ADDENDUM NO. 2

**Snell Building (SNLB) Deans
Office Remodel**

WPA ARCHITECTURE

April 2, 2024

A9.1

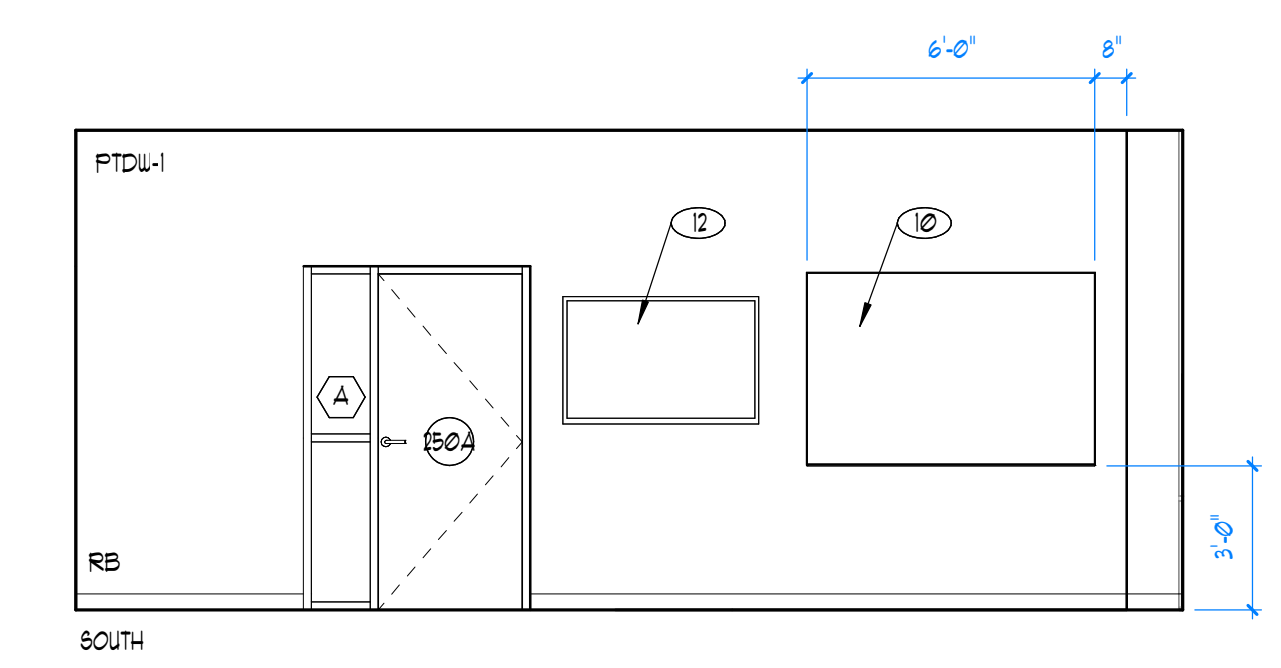
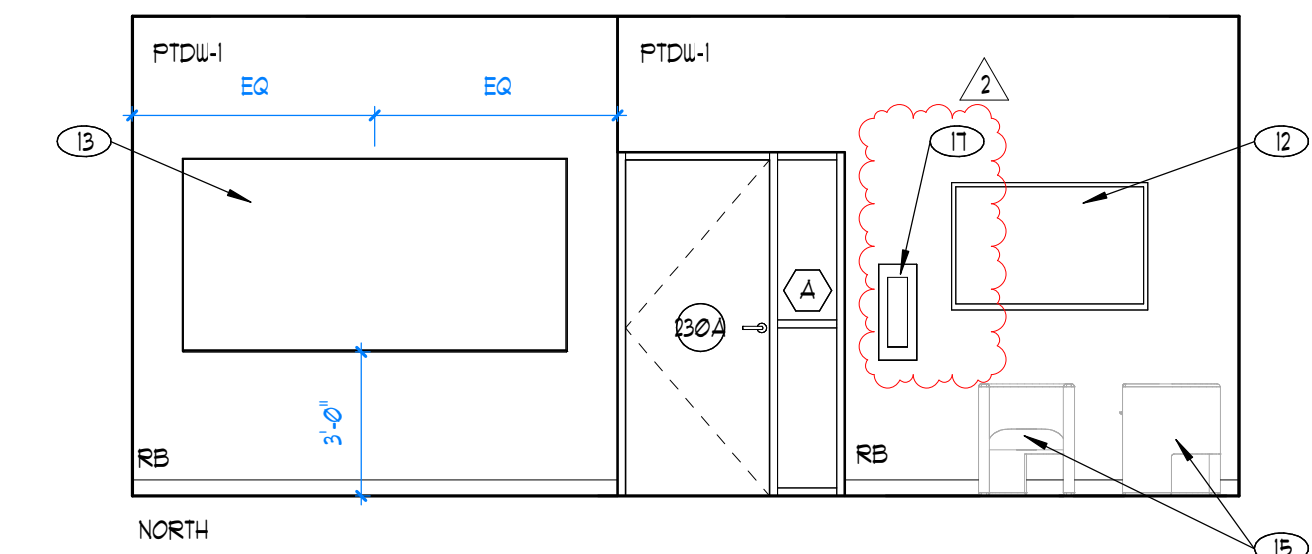
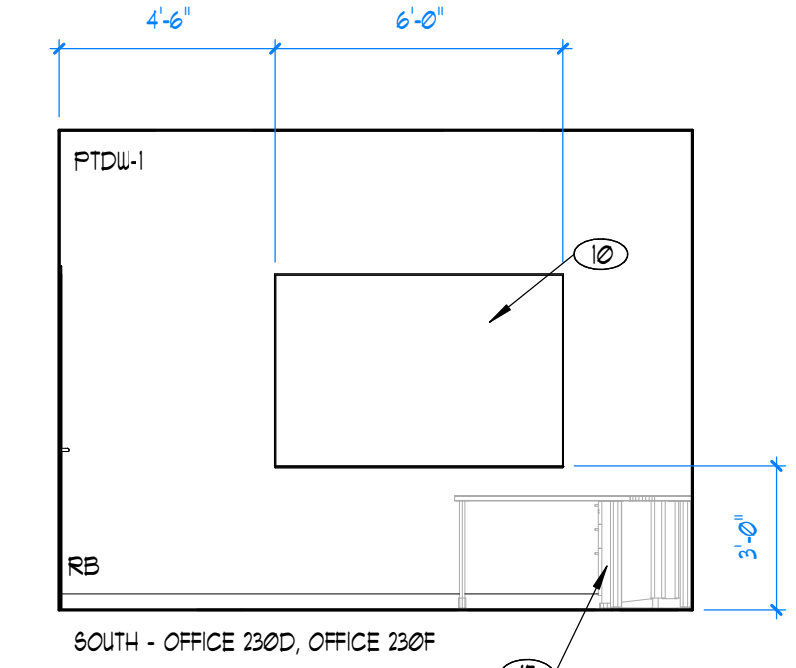
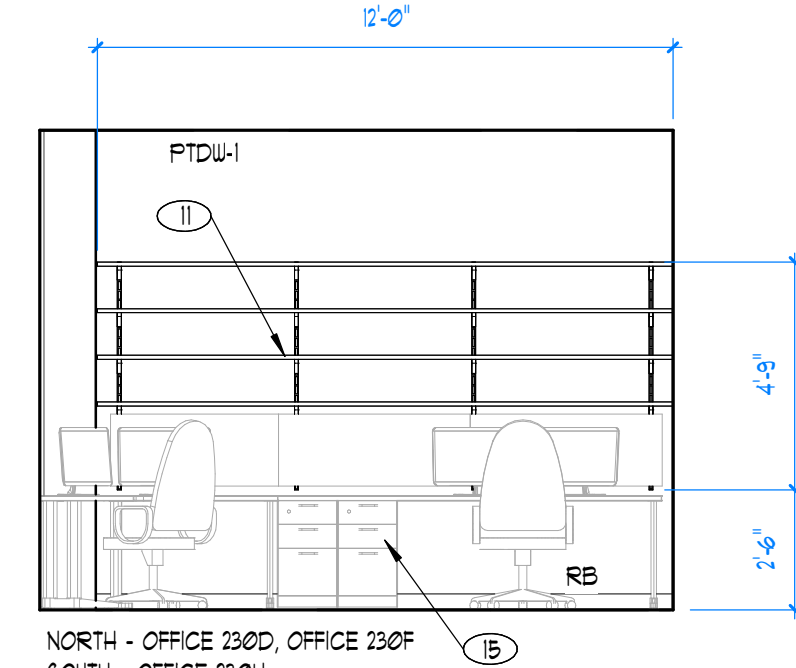
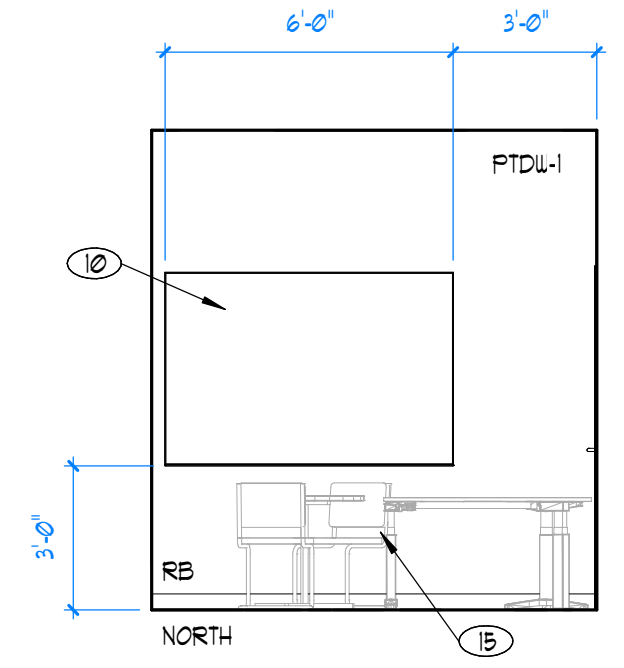
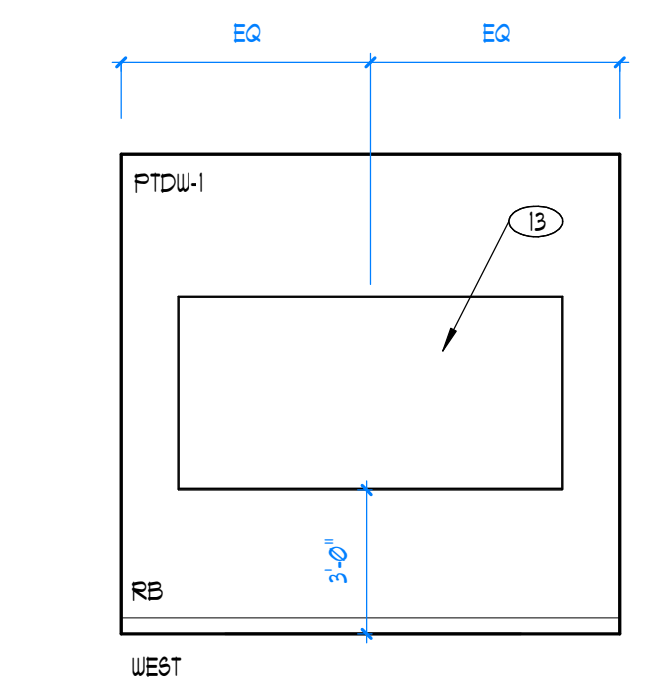
Sheet A9.1 – Clarified the finish called out in sheet notes 3, 4, 11, 14, and 16. Detail 5, added Surface Mounted Fire Extinguisher Cabinet.

1. Per A3.1, shelving is noted to be a white melamine w/ plastic edges, but A9.1 sheet notes 11 & 16 direct to match door color and wood species. Please advise. **Shelving will be white melamine w/ plastic edges. See Addendum 02.**
2. Per Remodel Plan 2/A2.1, (10) 8' x 4' and (8) 6' x 4' whiteboards are

6. A3.1 finish legend includes Mark "Plam-1" noting hardwood cabinets w/ plastic laminate boxes. However, "Plam-1" is not noted elsewhere on the plans. Please confirm that cabinet construction in breakroom is per A9.1 and specs noting wood veneered plywood cabinet boxes. **Cabinet construction is per A9.1 and Specs. See Addendum 02.**

LEVEL 2 - DEMOLITION PLANS

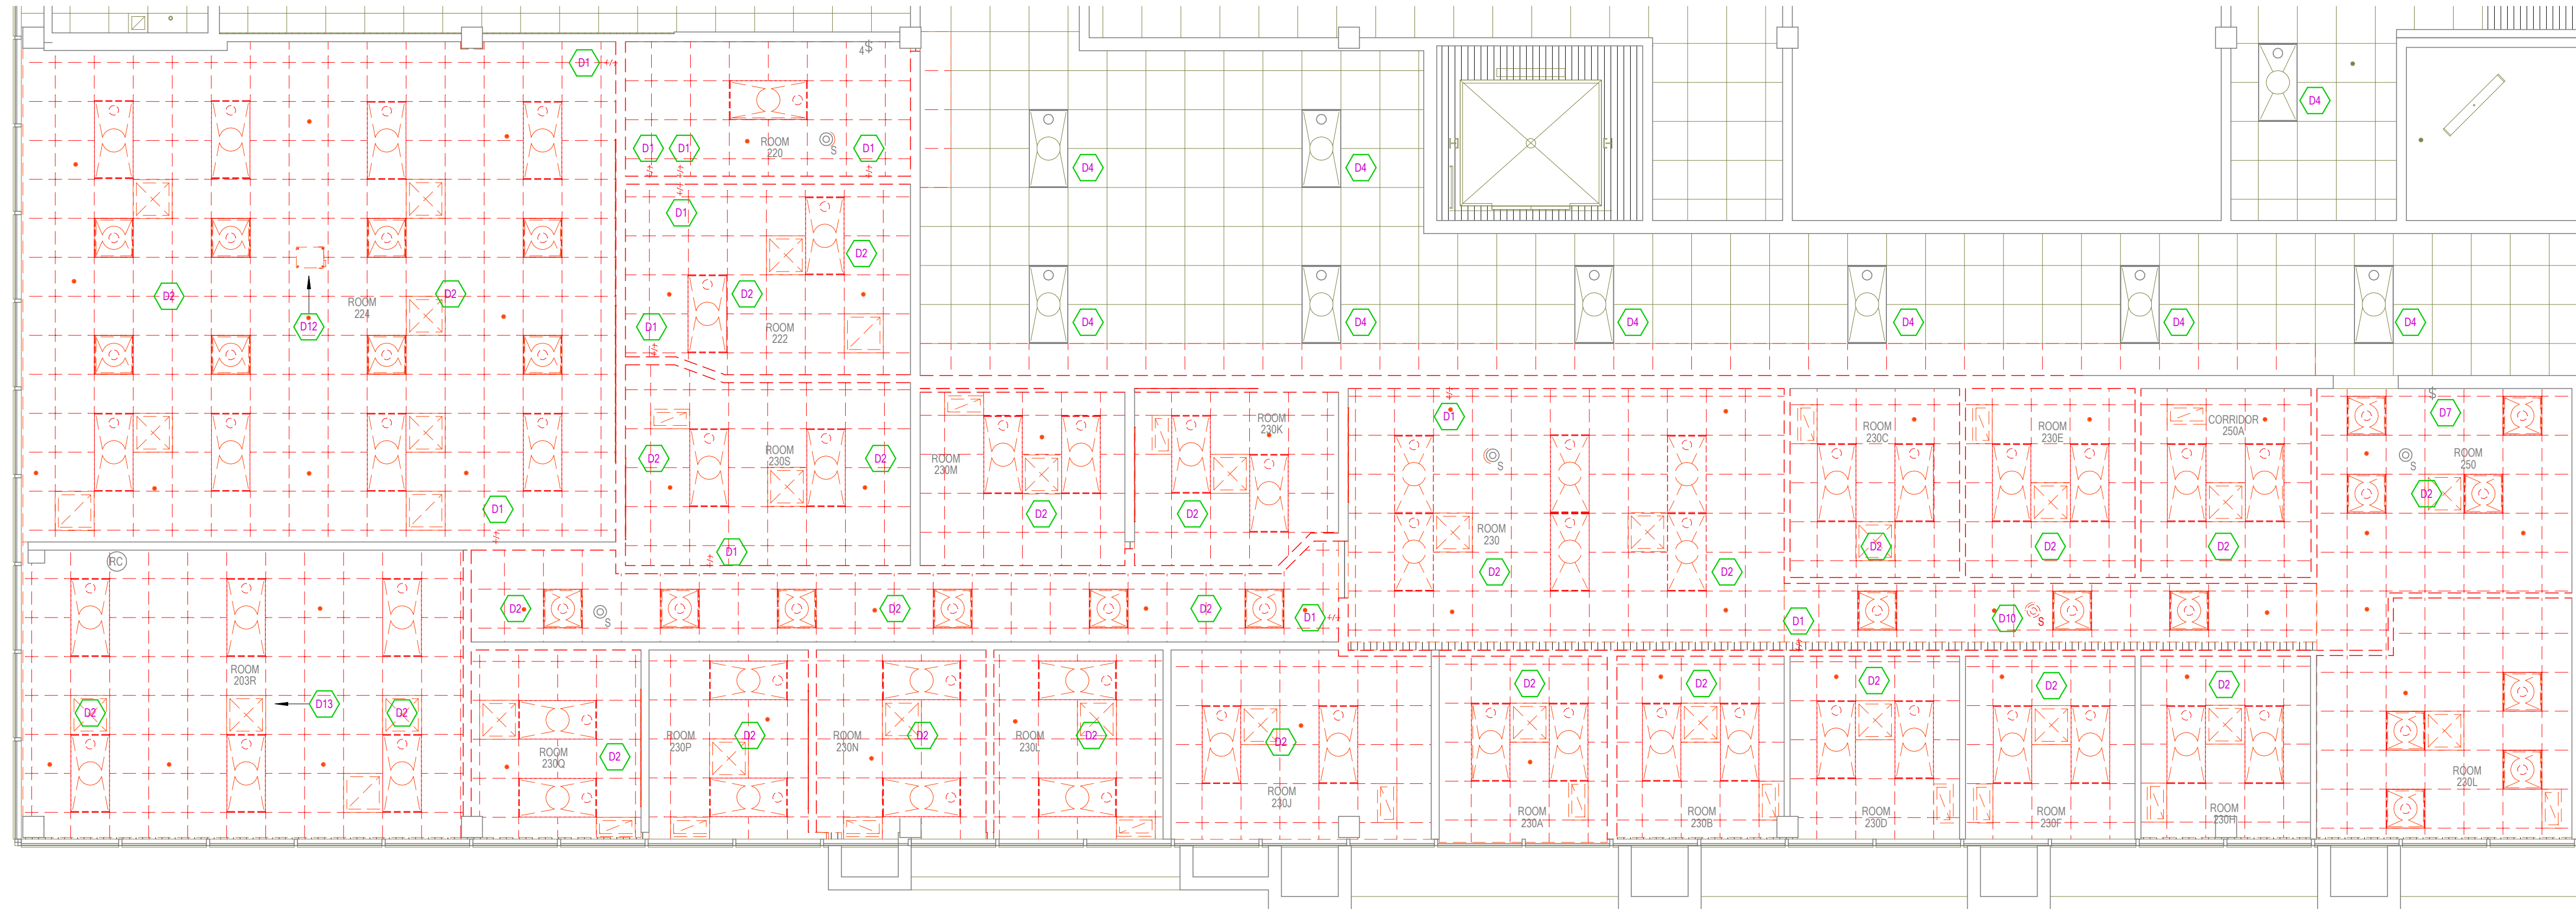
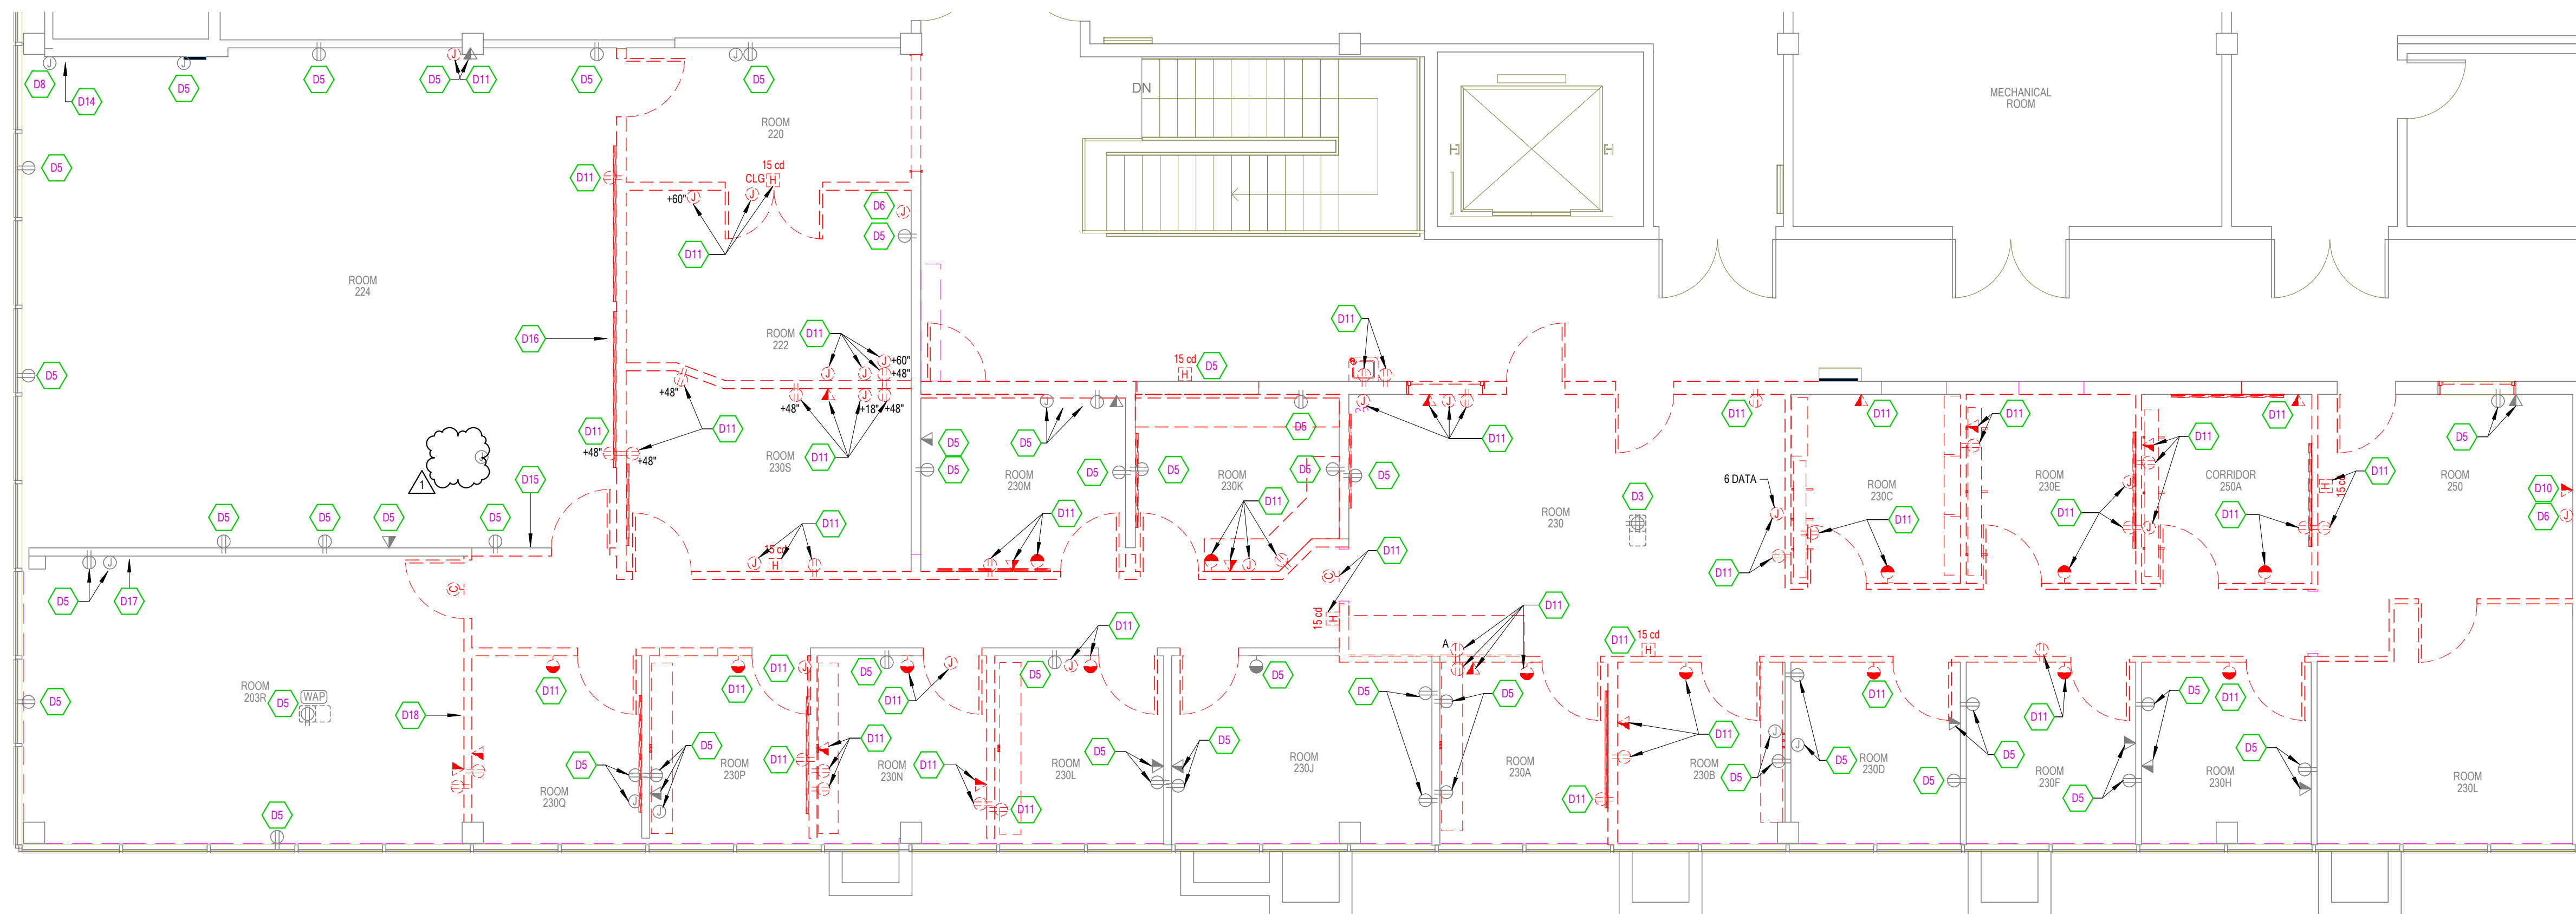
Sheet ED101 – Removed keynote 9

14. ED101 Note 9 calls for the electrical contractor to investigate power/data/av at the podium and notify the architect. Please advise how we are to quantify the work that is wanted for this note. As of right now there is not enough information to bid this keynote. Keynote 9 at the podium is changed to Keynote 15. See Addendum 02
